VIRGINIA ELECTRIC AND POWER COMPANY  
RICHMOND, VIRGINIA 23261

February 22, 1978

This is in response to your letter of February 2, 1978 regarding the possibility that the reactor cavity annulus seal ring or associated biological shielding could become missiles in the event of a loss of coolant accident (LOCA) pipe break inside the reactor vessel cavity. This response provides the information requested for North Anna Power Station Unit No. 1 and for Surry Power Station Unit Nos. 1 and 2.

NORTH ANNA - REACTOR CAVITY SEAL

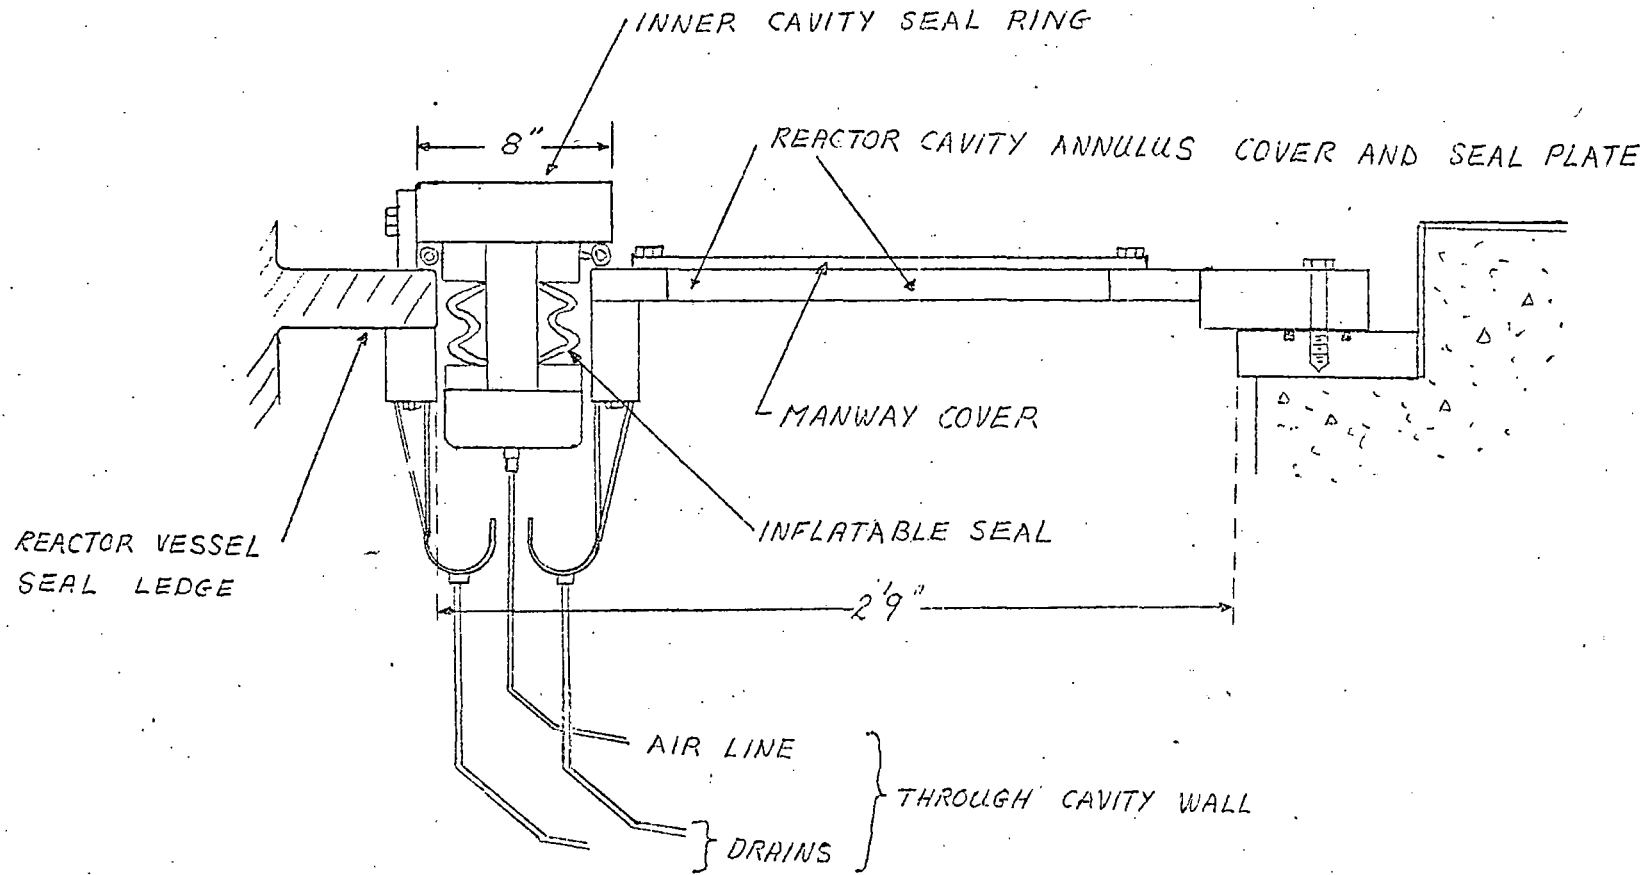
The reactor cavity annulus seal arrangement for North Anna Unit No. 1 is shown in Figure 1. The seal consists of a 2 inch thick plate which extends from the cavity edge to the reactor vessel seal ledge. This seal plate is installed only during refueling shutdown conditions. The seal plate is removed during normal operation. There is no biological shielding installed near or above the seal plate area.

SURRY - REACTOR CAVITY SEAL

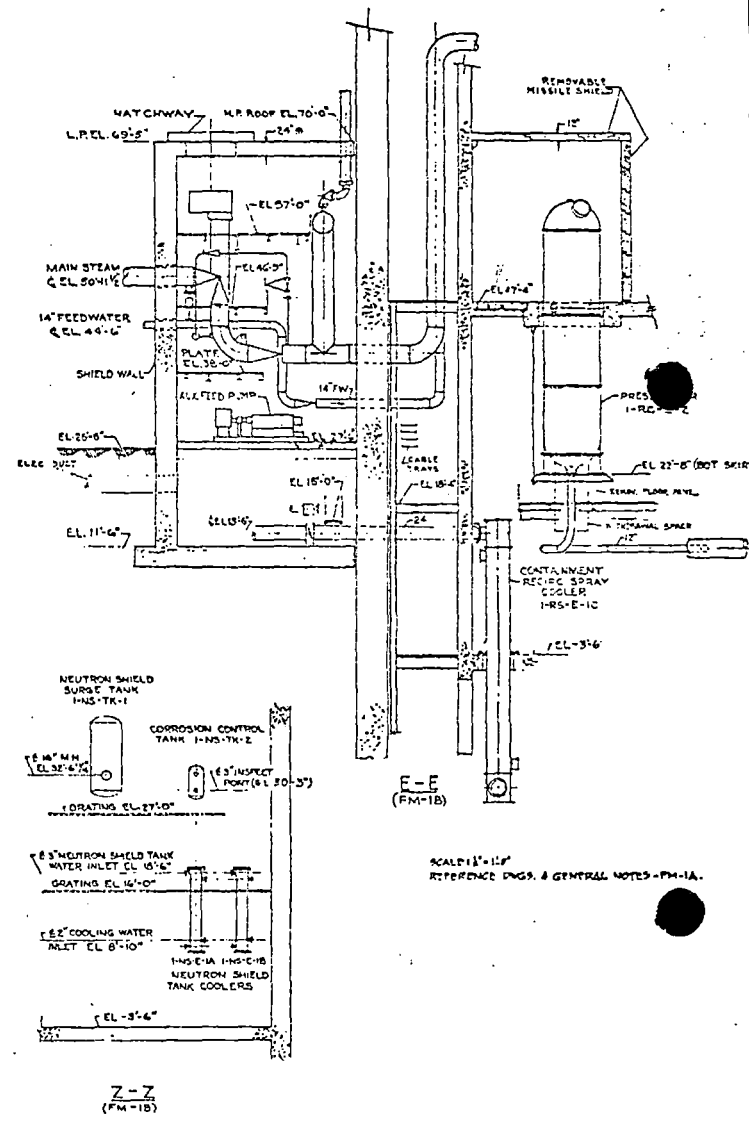
The reactor cavity annulus seal arrangement for Surry Unit Nos. 1 and 2 is shown in Figure 2. This seal consists of an inflatable inner cavity seal ring and a reactor cavity annulus cover and seal plate. The annulus cover plate extends from the cavity edge to approximately 6 inches from the reactor vessel seal ledge. The plate has two manways on opposite sides of the reactor. The annulus cover plate is left in place, with manways in place, during normal operation. The inner cavity seal ring is installed only during refueling operations, and is inflated to form a seal between the annulus cover plate and the reactor vessel seal ledge. The inner cavity seal ring is removed and stored during normal operation. Attached to the reactor vessel seal ledge and to the annulus cover plate are drainage troughs to collect any seal leakage. There are two drain lines and one air supply line which extend from the seal area through the cavity wall. The drainage troughs, drain lines and air supply line are left in place during normal operation.

- 1) A review of the design indicates that the annulus plate and manway covers will not become dislodged in the event of a LOCA, although plate anchor failure and significant cavity liner deformation is possible.

- 2) Drainage troughs and piping and the air supply line are unlikely to be dislodged or vented into the upper reactor cavity. The drip pans are constructed of 1/8" stainless steel abundantly bolt-to their support. The drainage troughs will deform significantly under a postulated LOCA event, but are unlikely to become missiles. The possibility of drainage or air piping lines being ejected is remote.

MACHINE LOCATION  
REACTOR CONTAINMENT  
VERTICAL SECTION, SH. I  
SURRY POWER STATION

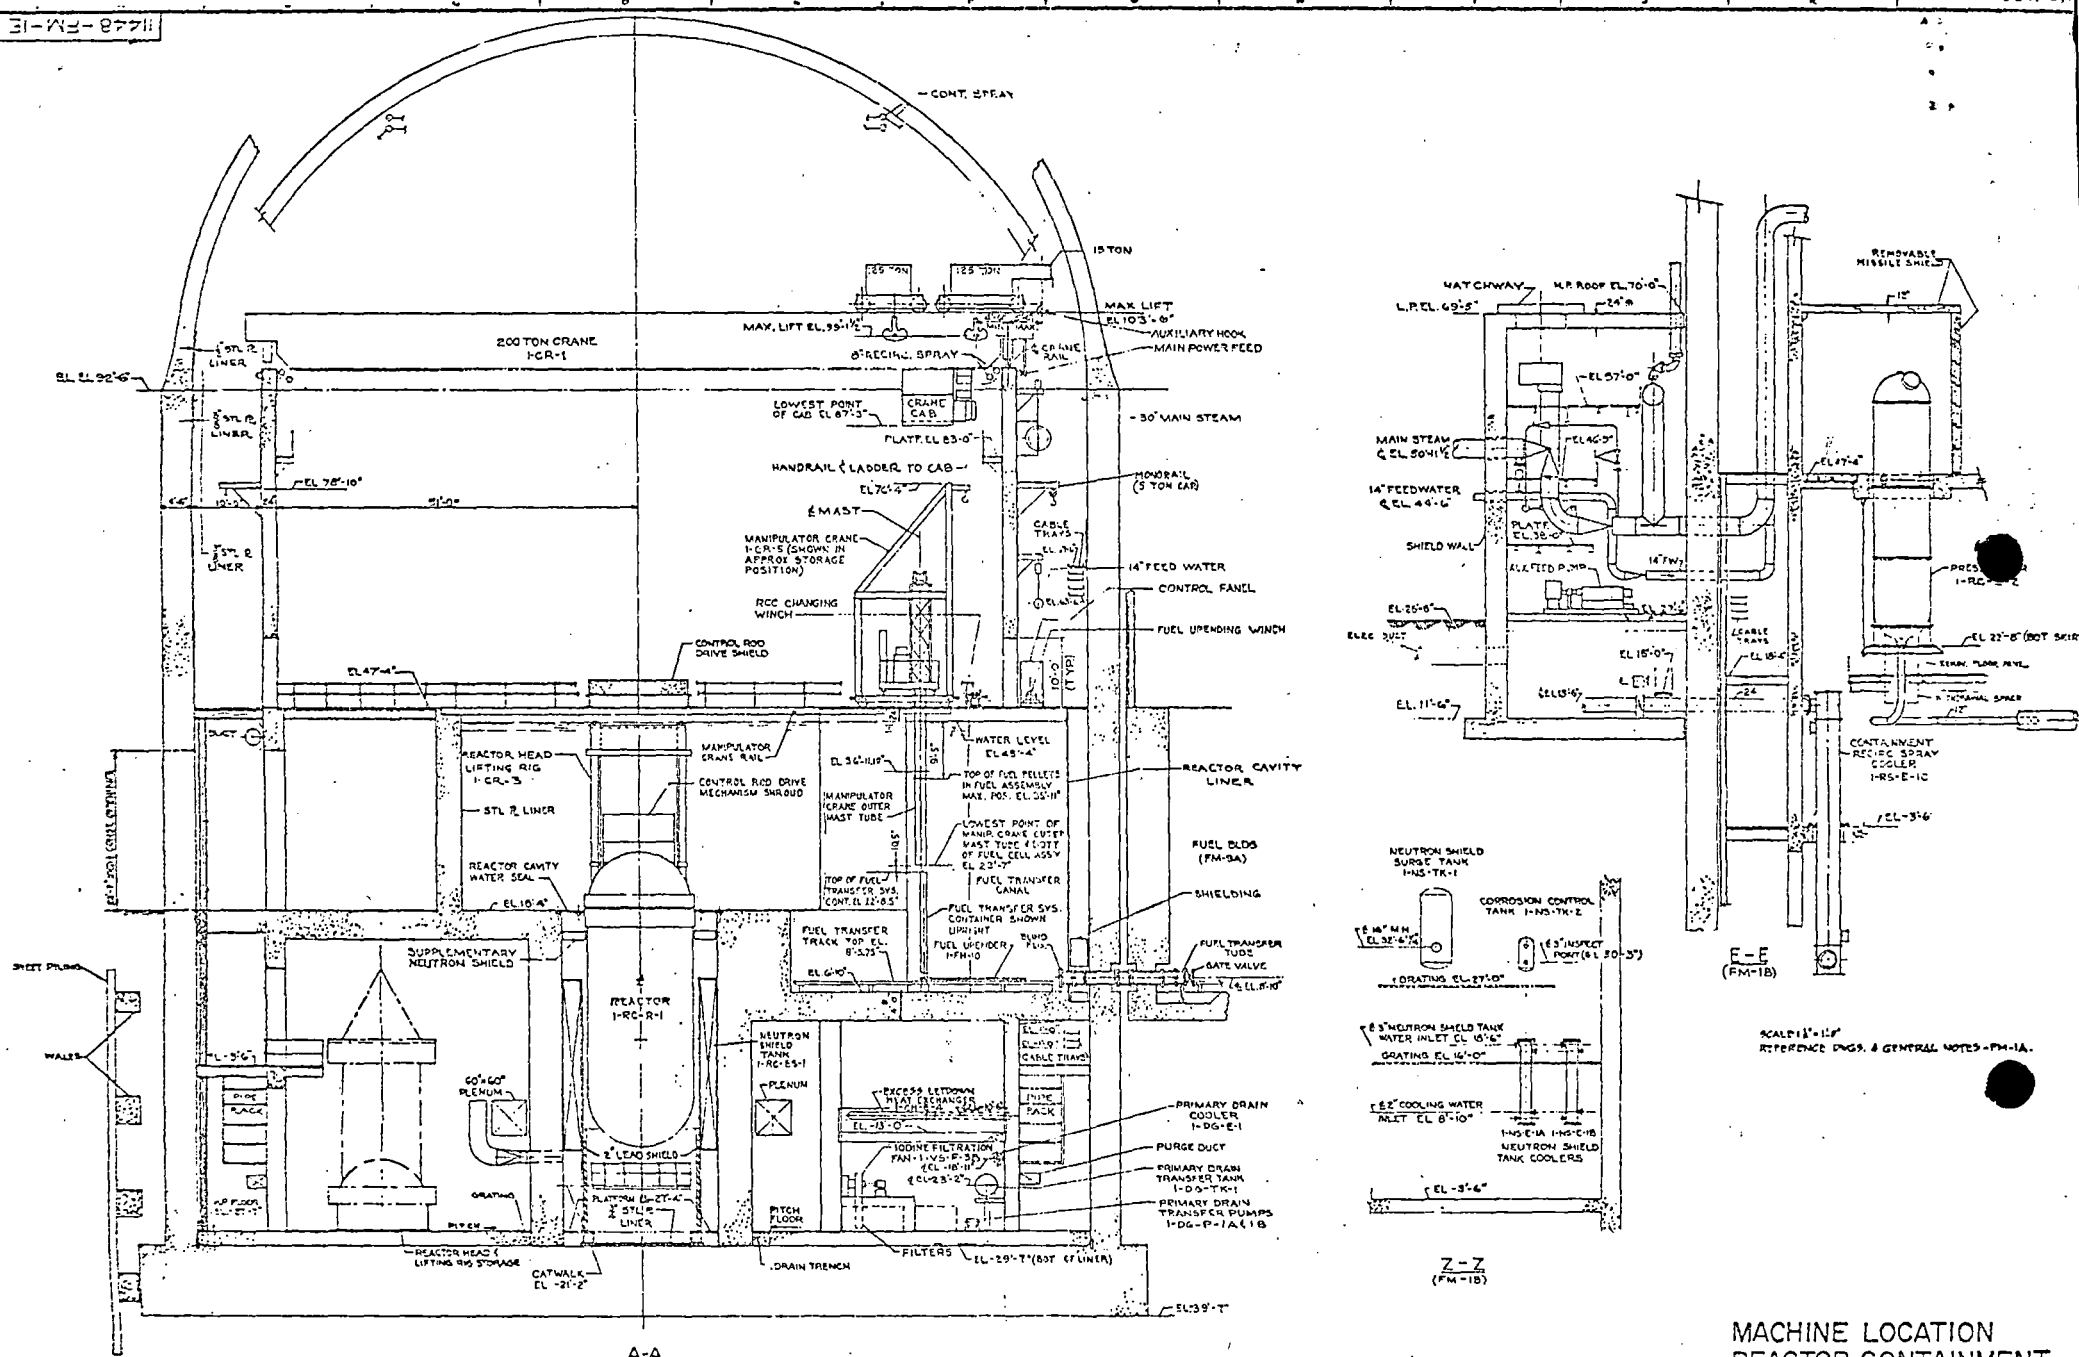
Located below the shield ring and above the reactor vessel nozzles is a supplementary neutron shield as shown on Figure 3. This shield consists of 12 wedge shaped segments of Benelex shielding incased in steel plate and supported by a steel framework which is bolted to the cavity wall.

- 3) The supplementary neutron shielding is supported only for dead weight by its support frame. The individual blocks will therefore be pushed upward by the postulated LOCA event and could be retained by the cover plate. For the shield block to leave the annulus area, the cover plate must have undergone gross deformation, and the shield block must "tumble" such that it can edge its way through the gap between the reactor vessel seal ledge and the cover plate. A detailed study to determine if the extent of deformation will allow the seal blocks to leave the annulus area has not been completed.
